# Masport®

Technical Bulletin Issue 79 - February 2011

## SP Driving Gears Change

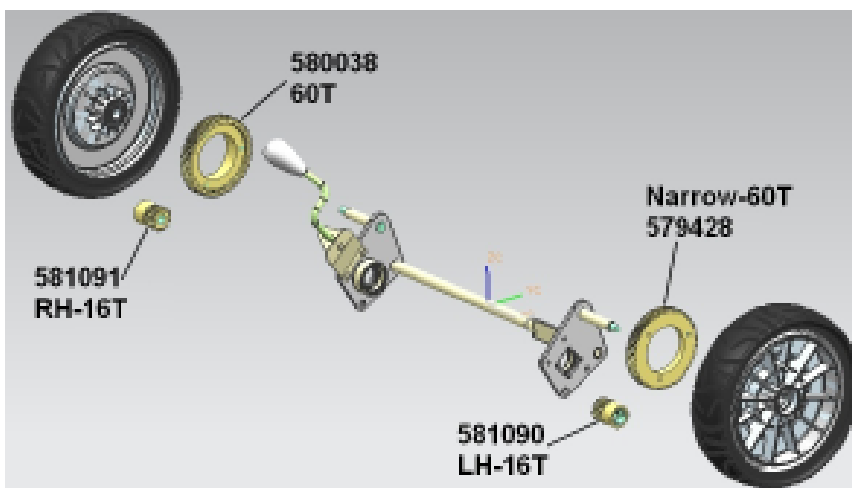
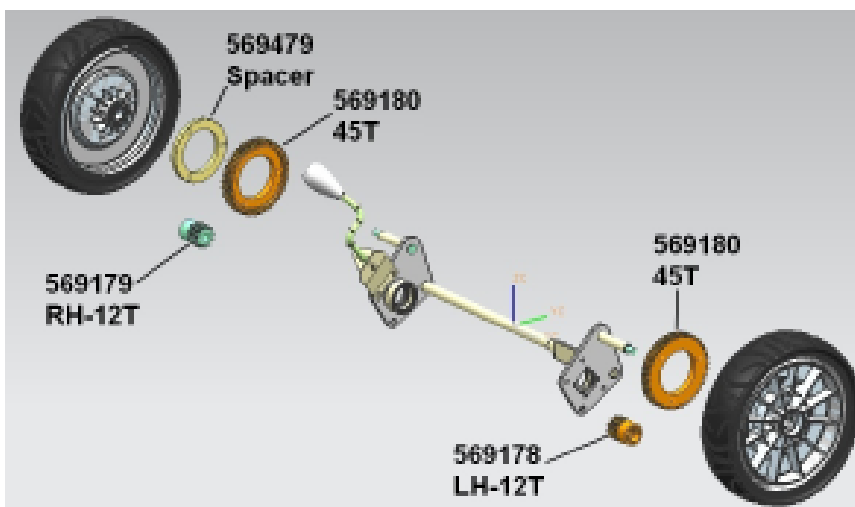
As part of the continuous process of improving the quality of our products, changes have been made to the SP driving gears on our self propelled mowers range. The old driving gears and pinions, which have 60 and 16 teeth are replaced with redesigned gear and pinions with 45 and 12 teeth, respectively. This will allow for a better meshing between the driving gears and pinions. At the same time, we standardized the width of the driving gears, using a spacer with the new driving gear to replace the old thicker driving gear. Starting in **May 2010** from serial number **7303554**, the new parts have replaced the old ones in production. Pictured below are the new and old gears, showing the differences between them.
